Access Compliance Report

Public Rights-of-Way

(Curb Ramps)

Intersection ID: 2769	Main Street: ASH_COVE_LN	Cross Street: BEAUVISTA_DR	Location: SE
ADA ID: D893D8298892	Ramp Type: PerpDiag	Initial Pass/Fail: Fail	Overall Compliance: No
			Severity Score: 21.25

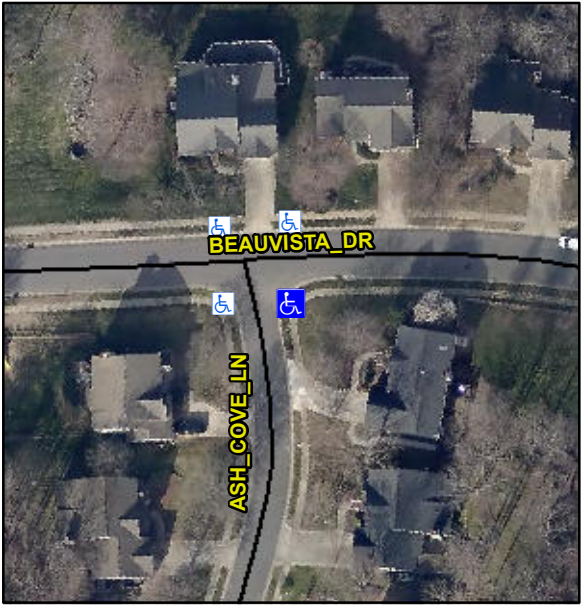
Codes/Mitigation Info/Possible Solution			Field Measurements/Component Compliance		
	Possible Solutions:		Compliance	Description	Data
	Remove & Replace Curb Ramp With Two New Directional Ramps or Equivalent.		No	Ramp Length (in)	48.0
			No	Ramp Width (in)	44.0
			N/A	Flare Type LT	N/A
			N/A	Flare Slope LT (%)	N/A
			N/A	Flare Traversable LT?	N/A
			N/A	Landing Length (in)	N/A
			N/A	Landing Width (in)	N/A
			N/A	Landing Slope (%)	N/A
			N/A	Landing X Slope (%)	N/A
			N/A	Landing Curb? (Y/N)	N/A
			N/A	Shared Landing?	N/A
			N/A	Gutter Ponding?	N/A
			N/A	Gutter Lip Ht (in)	N/A
			N/A	Painted X Walk1?	No
<p>Surveyor Notes:</p> <p>N/A</p> <p>PROW/ADA:</p> <p>Not Found, R304.5.1, R304.2.2</p>			To N	X Walk 2 Direction	To W
			N/A	X Walk 1 Width (in)	N/A
